Access Compliance Report Public Rights-of-Way (Curb Ramps)

Main Street: ANNIVERSARY_LN Cross Street: IRVINE_AVE Location: S

ADA ID: RPRK211018121817 Ramp Type: Type 1 - Perpendicular Diagonal Initial Pass/Fail: Pass Overall Compliance: No Severity Score: 16

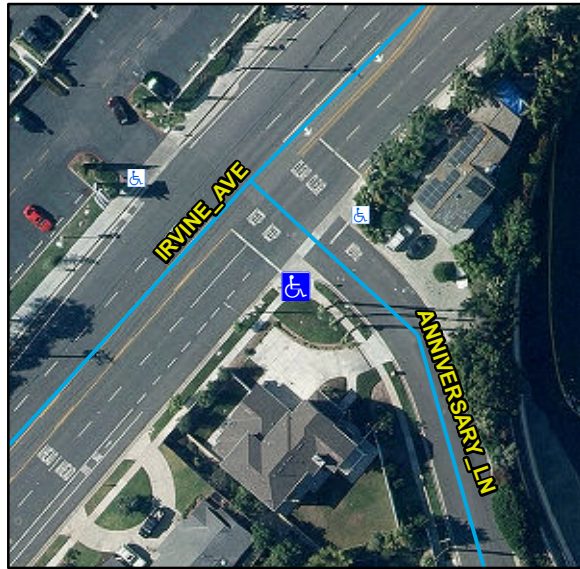
R304.2.2, R304.5.3, R304.2.1, R304.2.2-Perp, R304.3.2-Para, R305, STD 1115

Compliance	Description	Data	Compliance	Description	Data
N/A	Ramp Length (in)	116	N/A	Flare Type LT	
Yes	Ramp Width (in)	48			Sloped
Yes	Ramp Run Slope (%)	4.8	N/A	Flare Slope LT (%)	6
No	Ramp Cross Slope (%)	2.2	N/A	Flare Traversable LT	No
N/A	Landing Present	Yes	N/A	Flare Type RT	
N/A	Landing Length (in)	46			Sloped
Yes	Landing Width (in)	48	N/A	Flare Slope RT (%)	8
No	Landing Run Slope (%)	3	N/A	Flare Traversable RT	No
Yes	Landing Cross Slope (%)	1.8	No	DWS Provided	No
N/A	Landing Movement Obstructed?	No	N/A	DWS Contrast	N/A
	Landing Movement Type	N/A	N/A	DWS Length (in)	N/A
N/A	Landing Shared	No	N/A	DWS Full Width	N/A
N/A	Clear Space	Yes	N/A	DWS Offset Left (in)	N/A
N/A	Clear Space To Crosswalk (in)	48	N/A	DWS Offset Right (in)	N/A
N/A	Marked Crosswalk 1	No	N/A	Marked Crosswalk 2	No
	Crossing 1 Direction	NE		Crossing 2 Direction	N
	Marked Crosswalk 1 Width (in)	N/A		Marked Crosswalk 2 Width (in)	N/A
N/A	Ramp Inside Crosswalk 1	N/A	Yes	Ramp Inside Crosswalk 2	N/A

Crossing 1 Slope (%)	1.8		Crossing 2 Slope (%)	6.5
	Crossing 1 Cross Slope (%)	0.8		Crossing 2 Cross Slope (%)	1.4
Yes	Gutter Ponding	No	No	Curb Slope	7
Yes	Gutter Lip Height (in)	0		Road Run Slope (%)	1.4
Yes	Gutter Run Slope (%)	0.6		Road Cross Slope (%)	7
No	Gutter Cross Slope (%)	2.5			
Yes	Overall Surface Condition: Acceptable		Yes	Perp Joint Present	Yes
	Cross Gutter Present?	No		Spandrel Present?	Yes
	Replace Cross Gutter?	N/A		Replace Spandrel?	No

Remove & Replace Curb Ramp With Two New Directional Ramps or Equivalent. Remove & Replace Gutter.
